August 17, 2004
ASARCO BLACK PINE MINE
2004/2005 INTERIM RECLAMATION PLAN FOR THE COMBINATION MINE AREA
AND FINAL RECLAMATION PLAN FOR THE BLACK PINE MINE
DRAFT CHECKLIST ENVIRONMENTAL ASSESSMENT

OPERATING PERMIT NO. 00063

PROJECT: Black Pine Mine

Figure 3-2

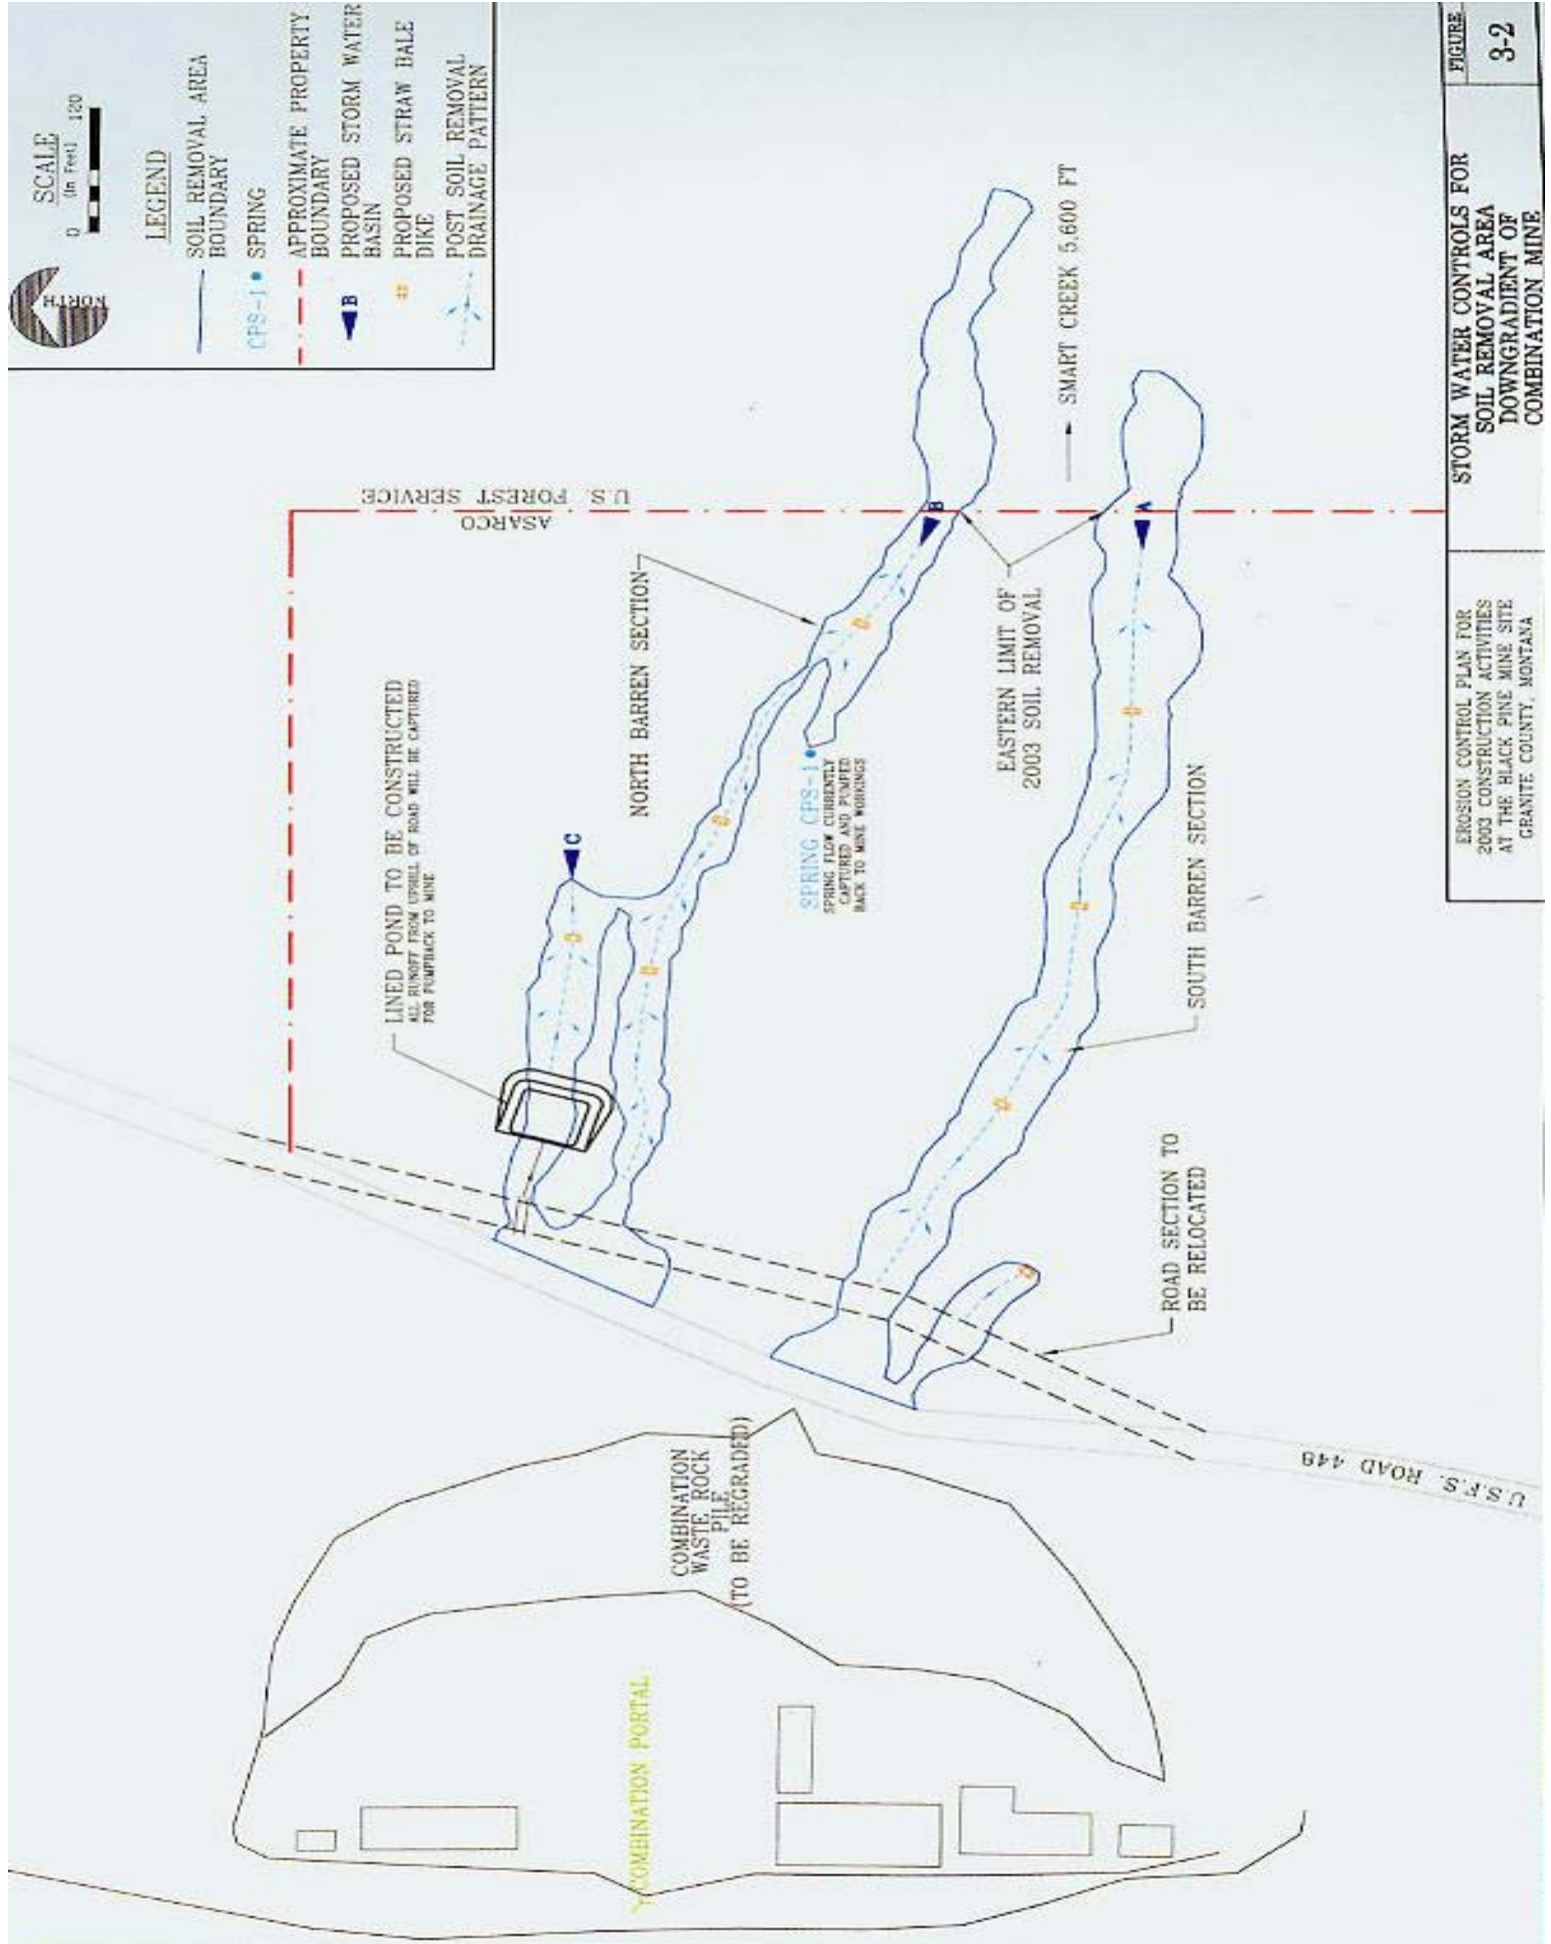
Modification 16: Several items specified in ASARCO's Erosion Control Plan for 2003 were not implemented. Those items need to be completed in order to achieve the level of erosion control needed at the Combination Mine.

- a. The toe diversion below the waste rock would be lined with PVC as was specified by ASARCO in its Erosion Control Plan for 2003 and was not done. Lining of this diversion along the roadside would reduce the amount of water reaching the underground seepage collection system.
- b. The sediment basins at the lower end of the trenches dug to remove contaminated soils in the Combination Soils area need to be constructed to trap water and sediment and prevent them from reaching wetlands on USFS lands. The basins would be located on ASARCO property adjacent to the USFS boundary.

Stipulation 16: ASARCO would implement two items specified in its Erosion Control Plan for 2003 Reclamation Activities (Hydrometrics 2003b).

- a. ASARCO would line the toe diversion also referred to as the runoff collection or roadside ditch below the waste rock dump with PVC as described in its Erosion Control Plan for 2003 Construction Activities (Hydrometrics 2003b).
- b. ASARCO would construct the sediment basins at the end of the reclaimed trenches in the Combination Soils area in 2005.

Drawing 1

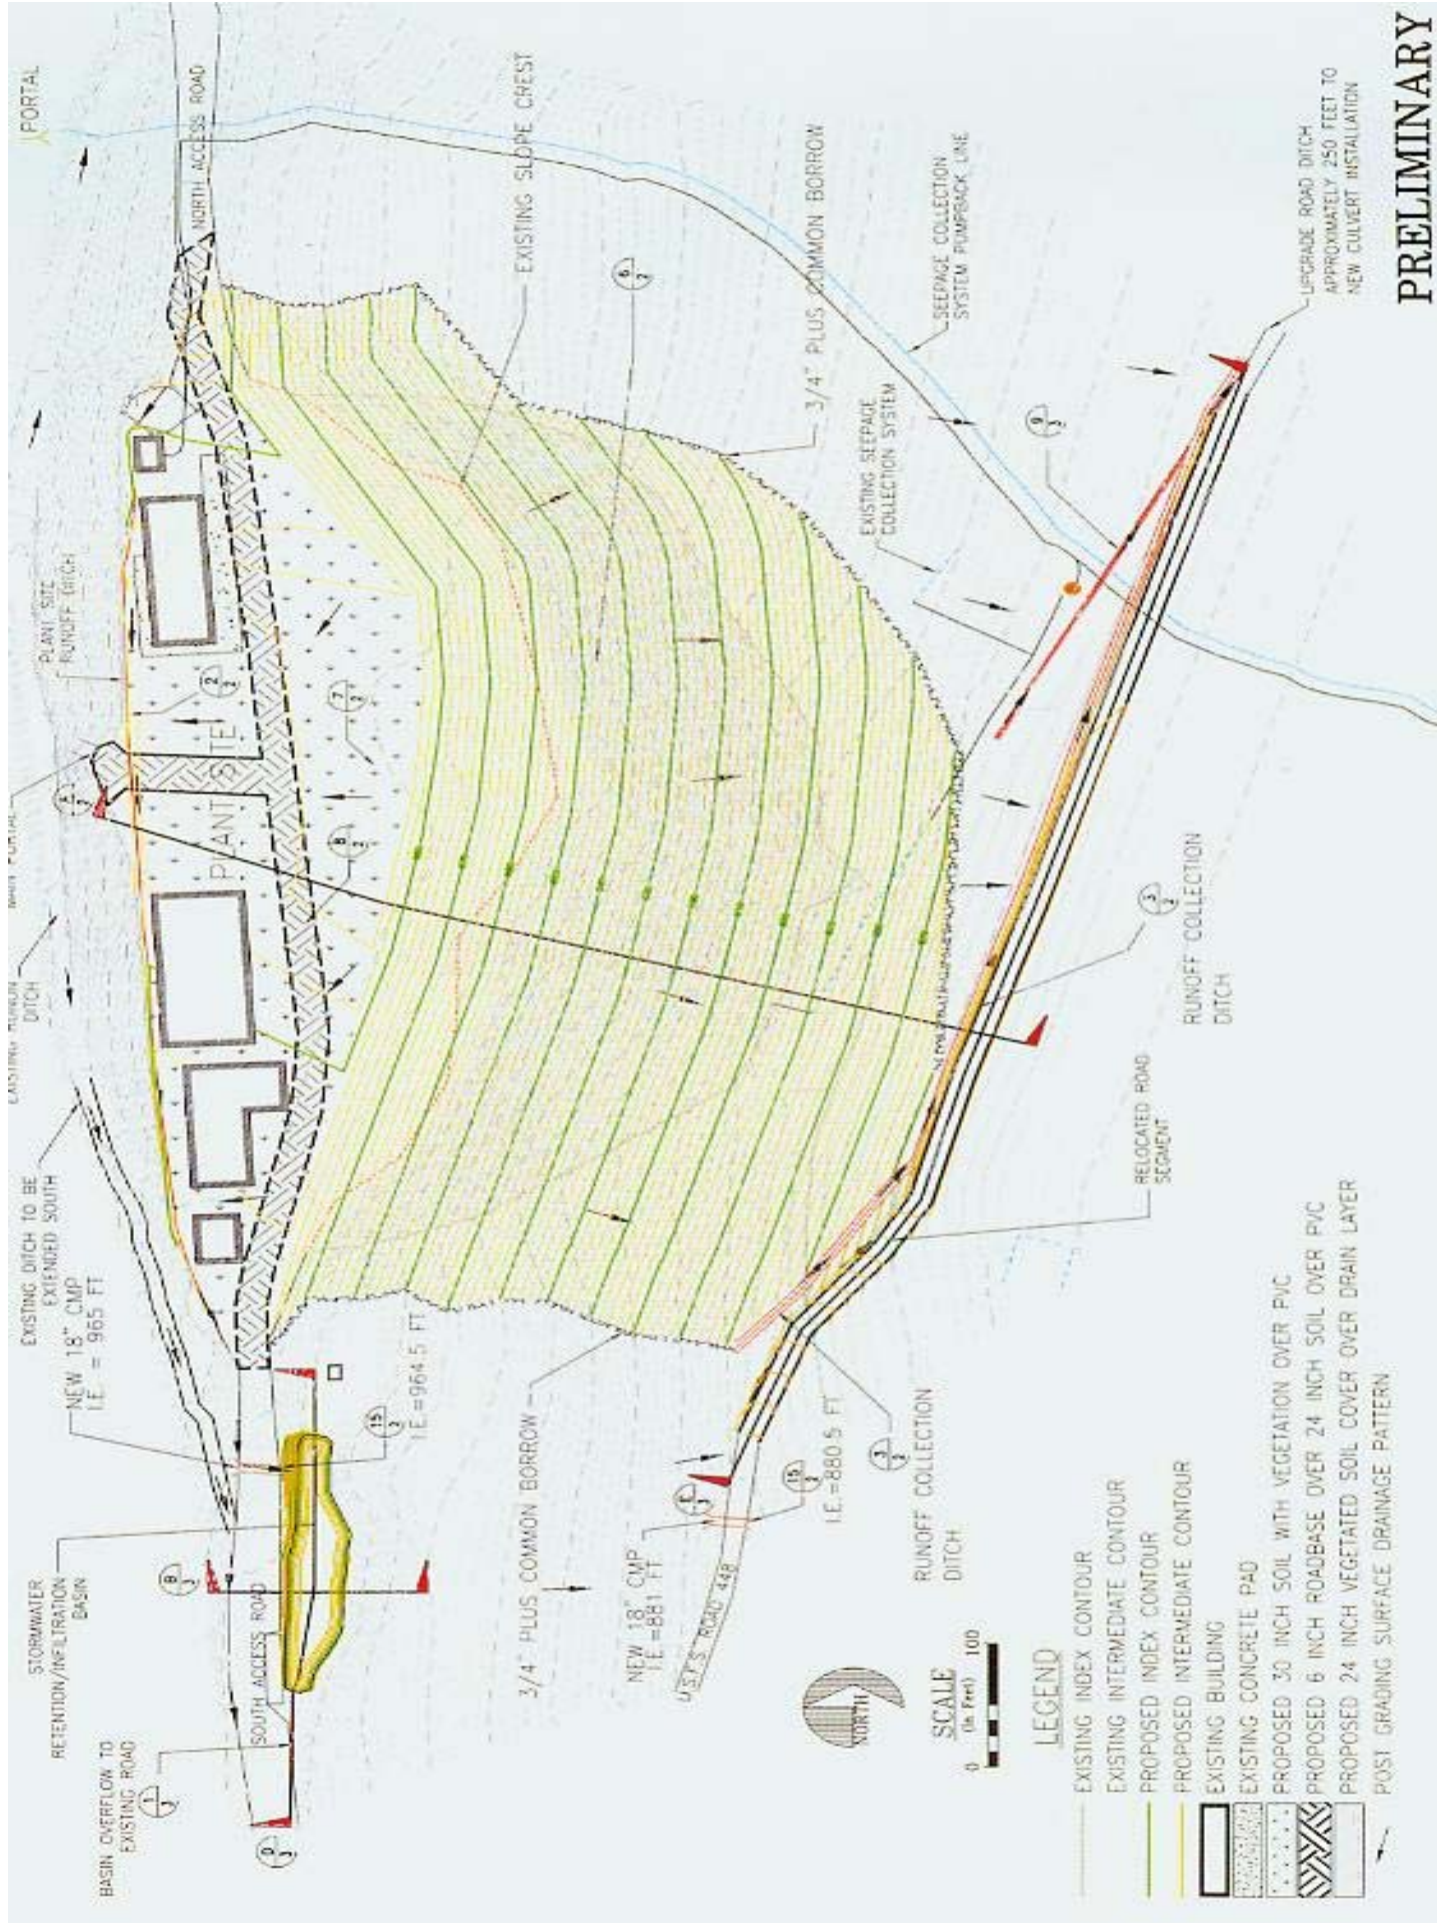
Modification 3: Lodgepole pine seedlings would be planted on the Combination Mine waste rock dump slope in 2005 to provide long-term water uptake on the waste rock dump slope and enhance reclamation success. Tubling seedlings would provide more rapid establishment of lodgepole pine than bare-root stock. No tree seedlings would be planted on the waste rock dump top as tree roots might possibly penetrate the liner.

Modification 5: The gates prohibiting traffic across the waste rock dump should remain in place to discourage public traffic on the reclaimed access roads and across the Combination Mine waste rock dump. This would improve the potential for successful revegetation of the waste rock dump surface and roadway. ASARCO may decide to remove the gates once vegetation is permanently established on the site after final reclamation is completed.

Modification 6: All road beds would be ripped to 12 inches before topsoil is installed to ensure an uncompacted rooting zone. Ripping had not been specified for the roadway over the Combination Mine waste rock dump. Ripping was proposed by ASARCO prior to regrading, but should also be done after regrading to ensure a sufficient and uncompacted rooting zone.

Modification 11: The installation of gutters on the buildings provides a focused discharge point at the base of the gutters. The force of water draining at these points could erode the cap beneath the downspout. In addition, the amount of snow pack at the site that collects on the roof could rip off or damage the gutters.

The gutters would be eliminated. The connection of the PVC liner to the buildings needs to be modified to reduce the potential for water to seep between the building and the liner into the waste rock beneath and to reduce the potential for erosion from the gutter downspouts by allowing the snow to just slide off the roof and melt on the reclaimed and lined surface.

Stipulation 3: ASARCO would plant tubling lodgepole pine trees on the Combination Mine waste rock dump slope in 2005. The revegetation goal would be to achieve 400 trees/acre.

Drawing 6

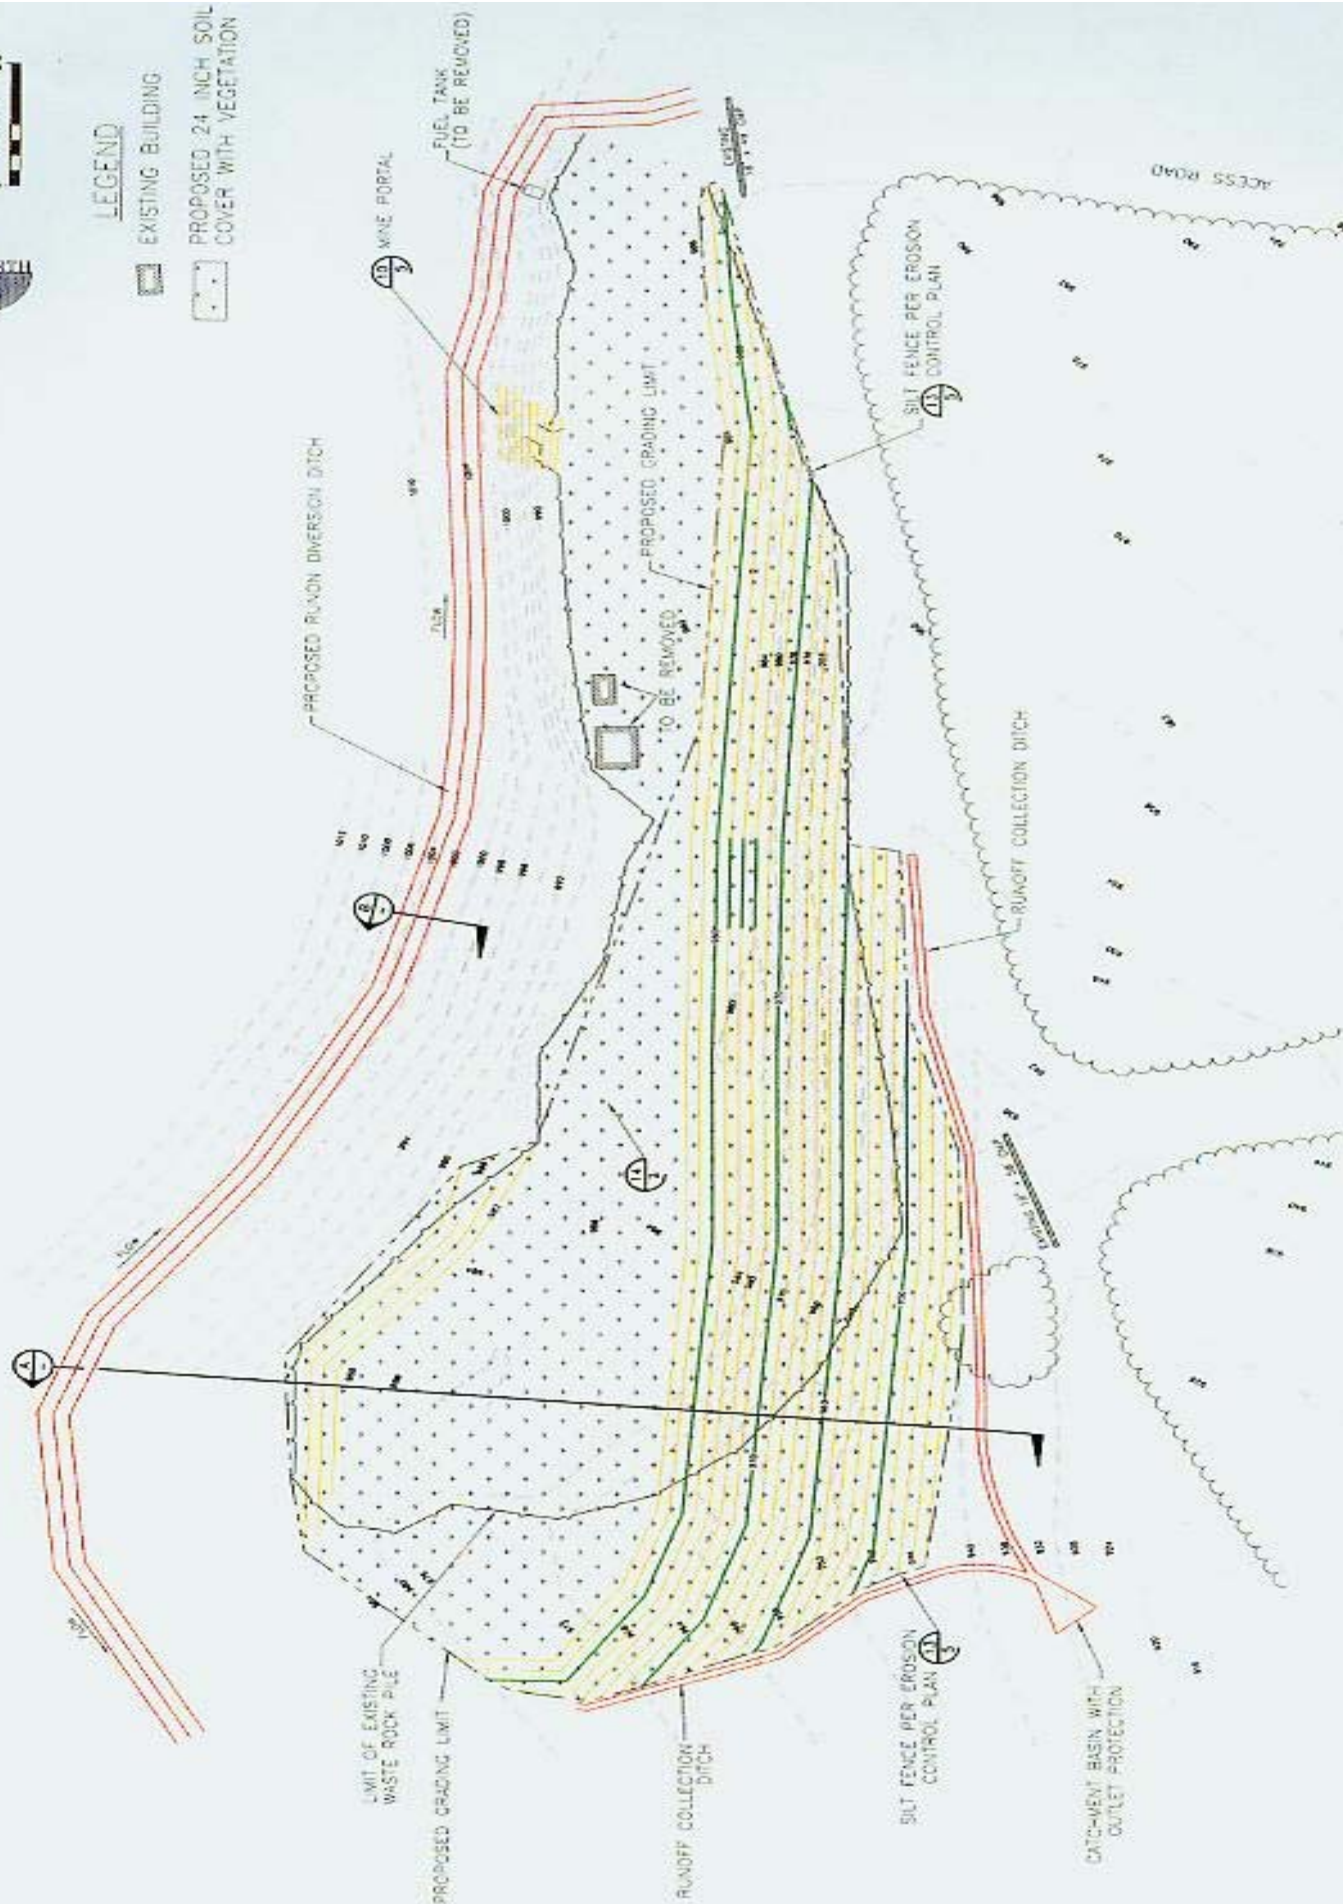
Modification 22: The Tim Smith #2 waste rock dump should be pulled back into the cut slope. The slope would be resoiled afterwards if ASARCO and the agencies determine the waste rock dump materials are too rocky or have insufficient fines to retain moisture necessary for plant growth. If the waste rock dump materials were adequate for plant growth, then additional soil/growth medium would not be required. If the waste rock dump materials were inadequate for plant growth then 12 inches of soil would be obtained from BPB-8.

Stipulation 22: ASARCO would regrade the Tim Smith #2 waste rock dump by pulling material from the waste rock dump slope and crest back into the cut face to reduce the slope and reclaim the cut face. ASARCO would test the waste rock dump material as to its suitability as a plant growth medium. The agencies would determine if it was suitable or not. If not, ASARCO would obtain 12 inches of soil material from BPB-8.
